MARINO ENGINEERING ASSOCIATES, INC.

January 23, 2017

Re: Brook Mine Permit Application

FIGURE 4.5 CARNEY COAL SEAM OVERBURDEN ISOPACH MAP (UPPER CARNEY WEST OF CARNEY SPLIT) WITH PROPOSED MINE LAYOUT

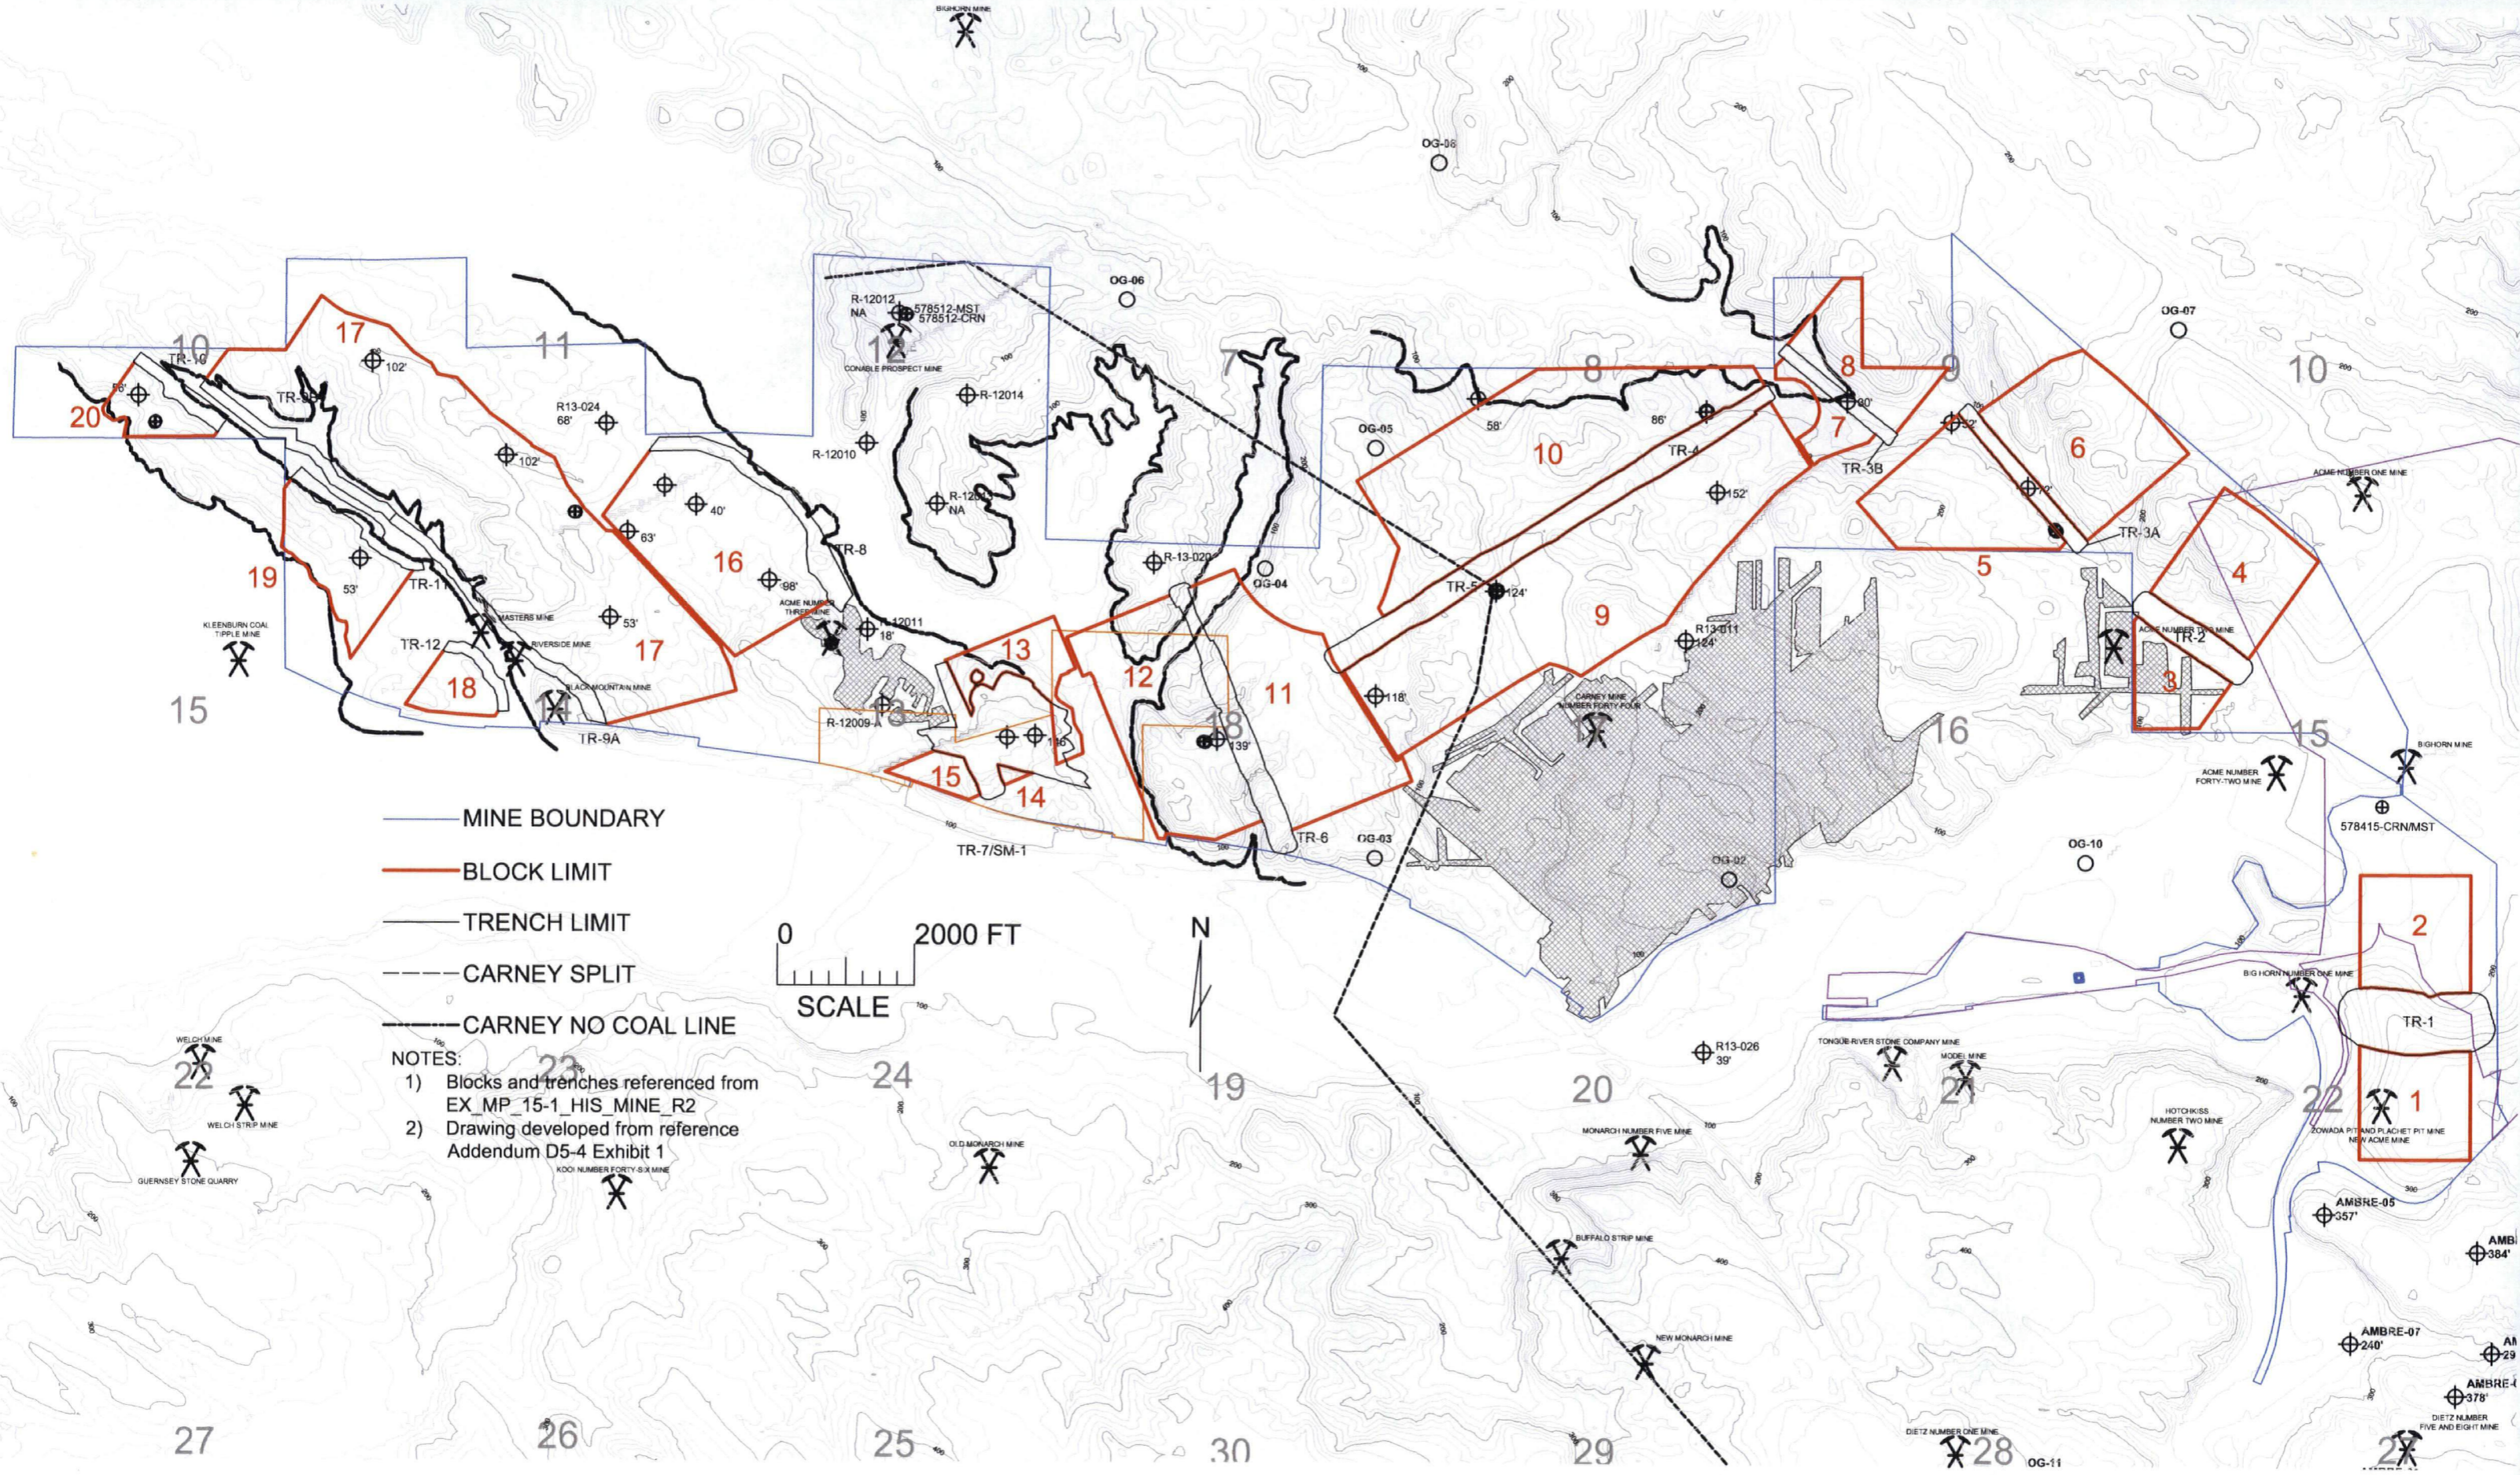
In order to better understand the ground conditions in the areas of proposed mining, the mining layout given in Figure 4.3 has been superimposed over the various isopach exhibits for the Carney and Masters seams provided in the mine application. These drawings are shown in Figures 4.5 to 4.12. Also, the mine block areas had been delineated on the various geologic cross-sections drawn by Ramaco across the site (see Figure 4.3). The modified cross-sections showing the mine block locations are shown in Figures 4.13 to 4.24. From this reported information, the Dietz, Monarch, Carney, and Masters related conditions per block have been summarized in Table 4.1.
